**CITY OF SAINT PAUL
HERITAGE PRESERVATION COMMISSION STAFF REPORT**

FILE NAME: 531 Dayton Avenue

CLASSIFICATION: Pre-Application Review

DATE OF REPORT: March 2, 2017

GARAGE FLOOR PLAN

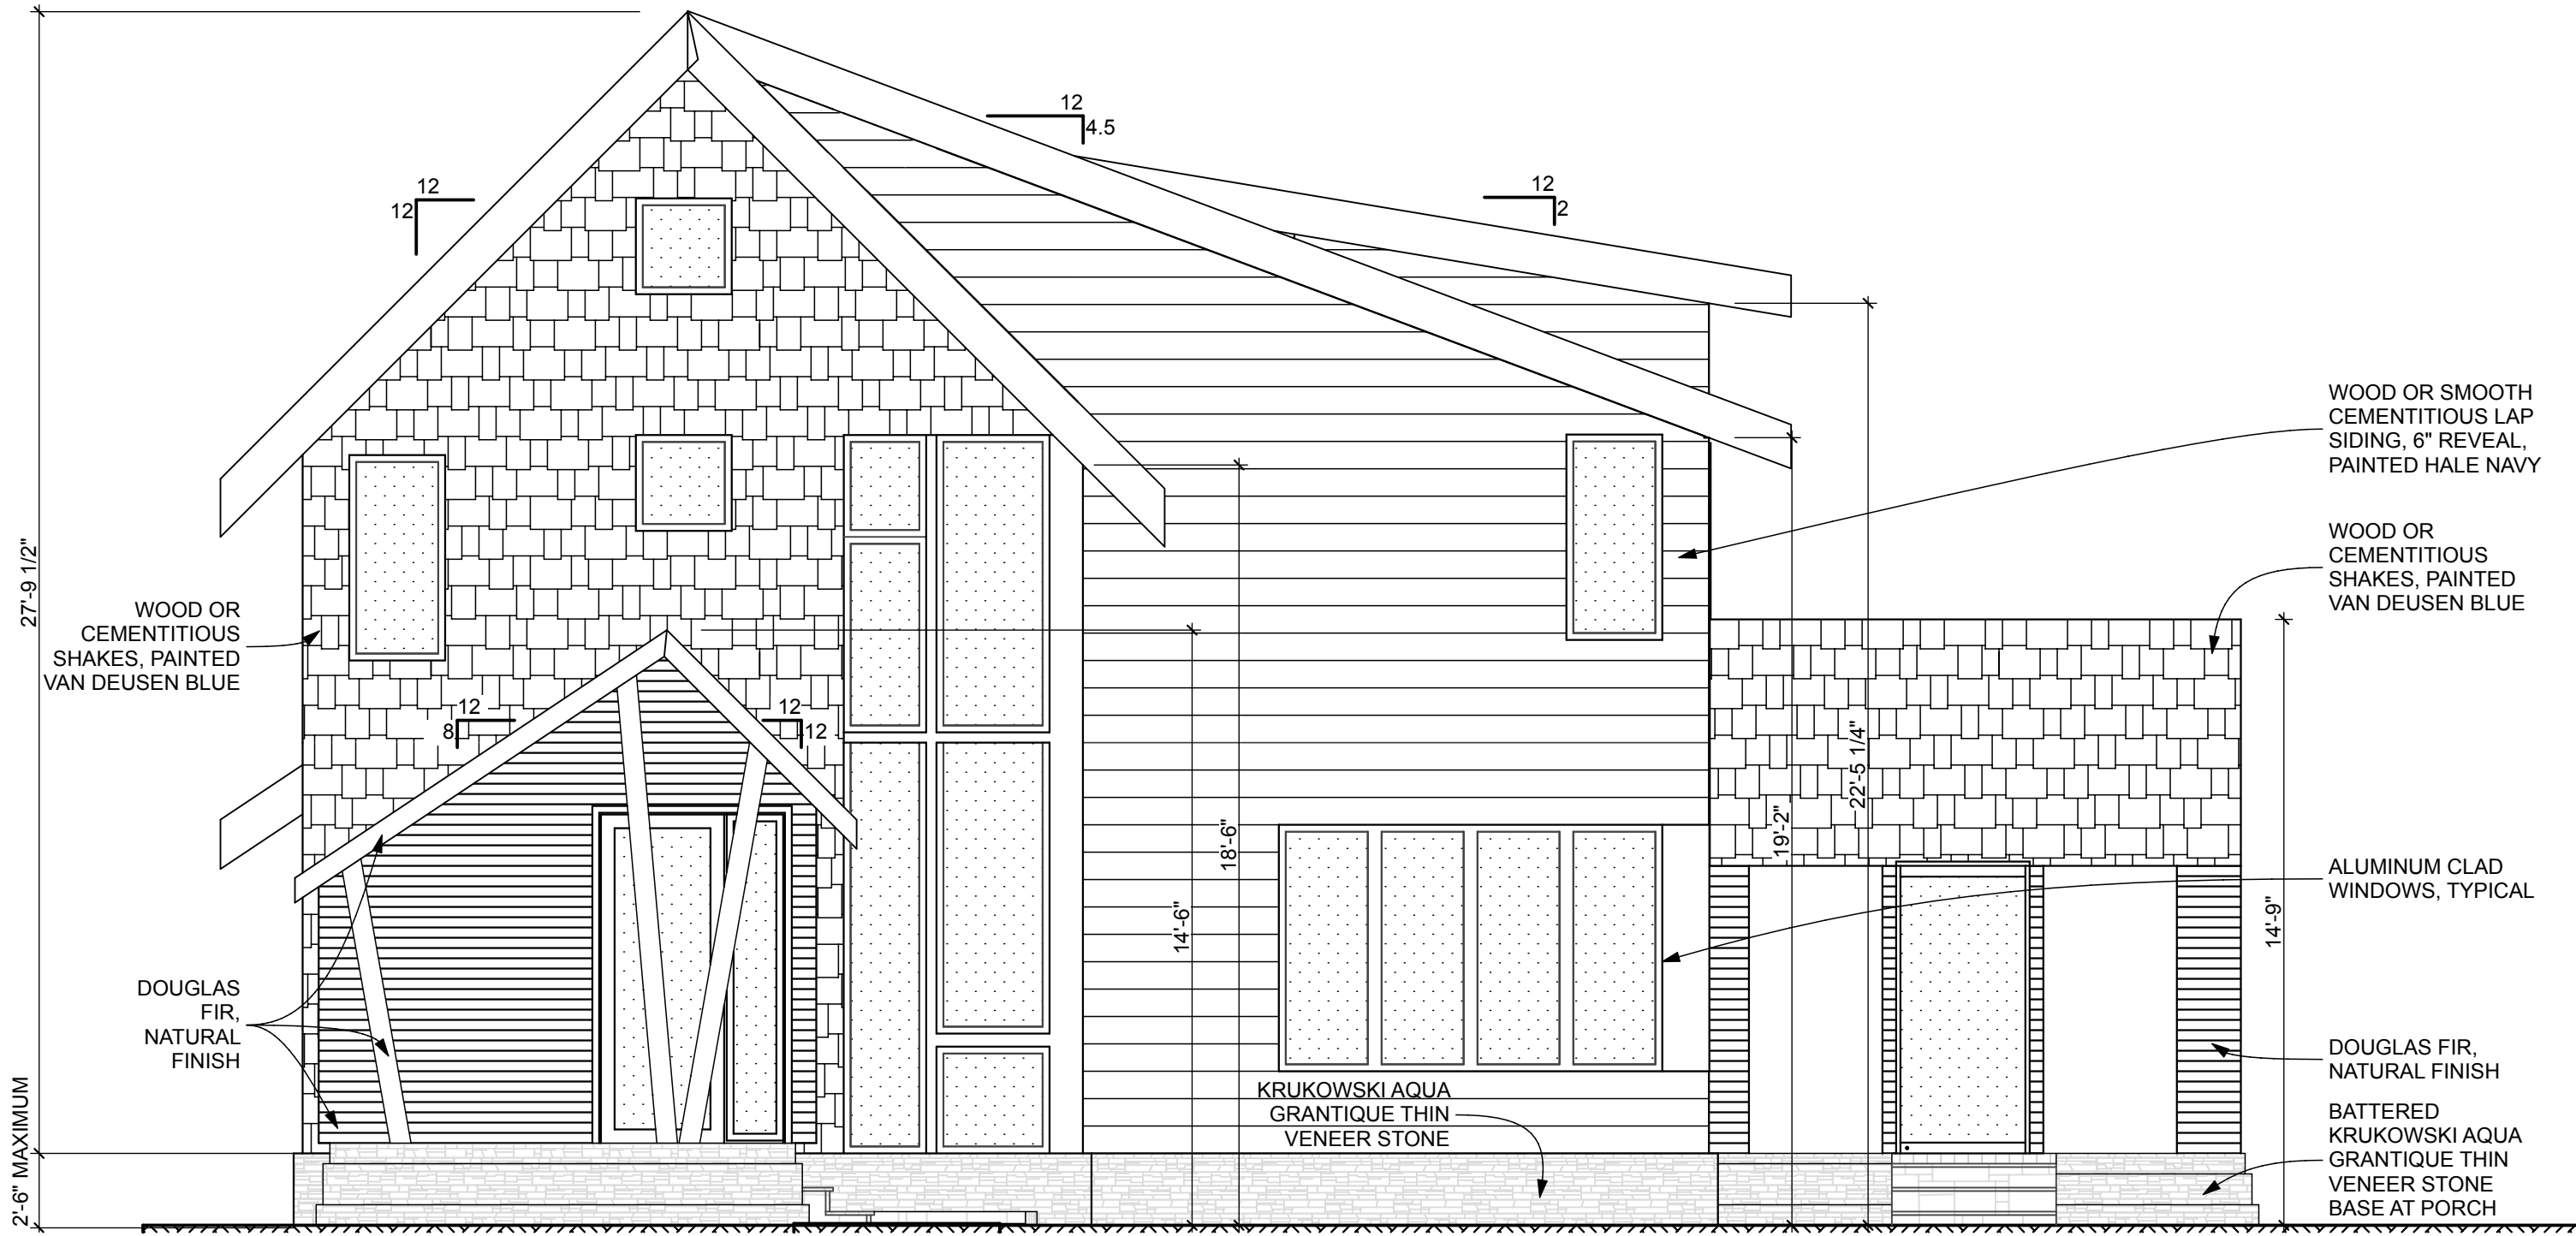
13. Garages and Parking. The detached garage is appropriately oriented toward the alley. It has similar design compatibility issues as the main building, such as massing, height, windows, doors, siding, and roof design, that require redesign to meet the district guidelines. New two-story garages such as proposed are not compatible with garages in the district, which are one-story unless they are historic carriage houses.
